CITY OF ALBUQUERQUE

**Re: Lots 12 & 13 Block 6 Unit 5 Volcano Cliffs SAD 227
8009 & 8015 Victoria Dr. NW
Grading & Drainage Plan
Engineer's Stamp dated: 8-27-17 (E10D037)**

Based upon the information provided in your submittal received 9/5/2017, this plan cannot be approved for Building Permit until the following comments are addressed.

Lots 12 and 13, Block 6 Volcano Cliffs Subdivision, Unit 5 GRADING PLAN			
DRAWING:	DRAWN BY:	DATE:	SHEET #
201702-GD-DWG	SH-B	8/27/2017	1

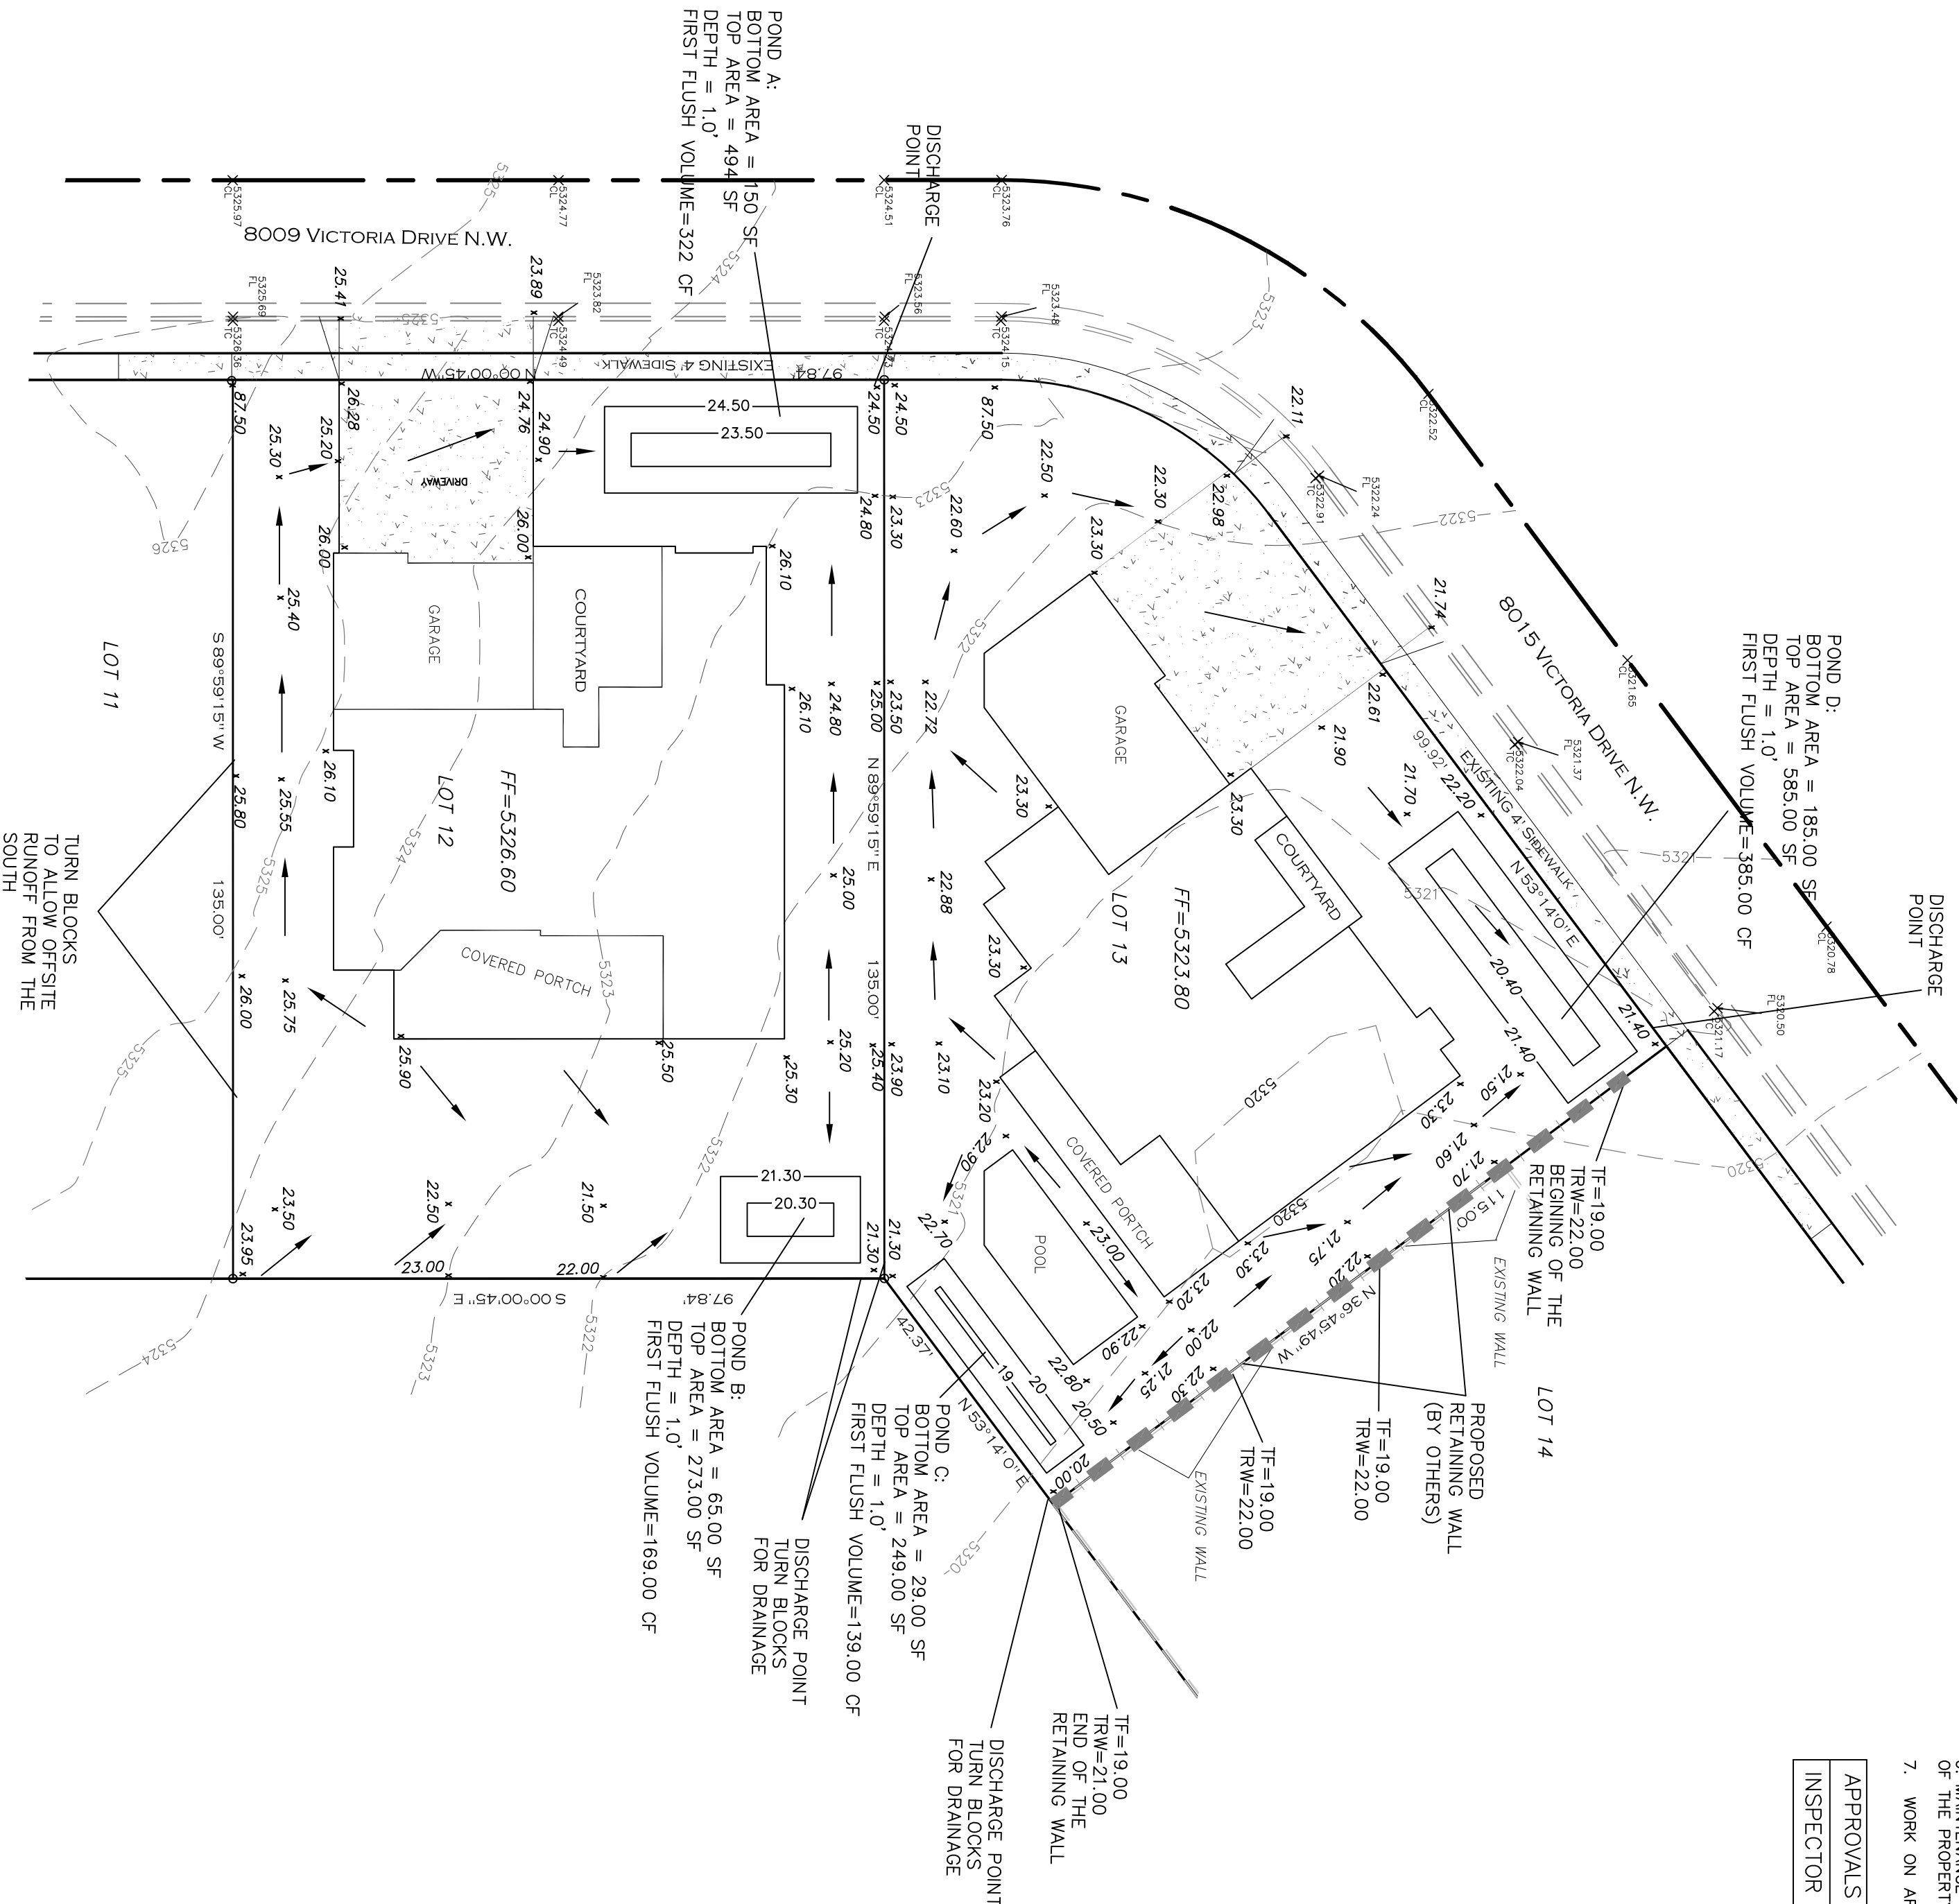
- Provide direction of roof flows. If flows are toward the front, how will these flows enter the ponding areas?
- Separate this one submittal into two submittals.
- Impervious area should be at 32%, or provide extra retainage for the larger area.
- Provide a table showing area's in percentage and in square feet.
- Provide how flows will cross the driveway and enter into the front yard pond.
- A pad certificate is required before a building permit is issued.
- Provide a statement on the plans that a separate permit is required for any retaining walls or garden walls.
- The weep holes are required to be 3" above grade.
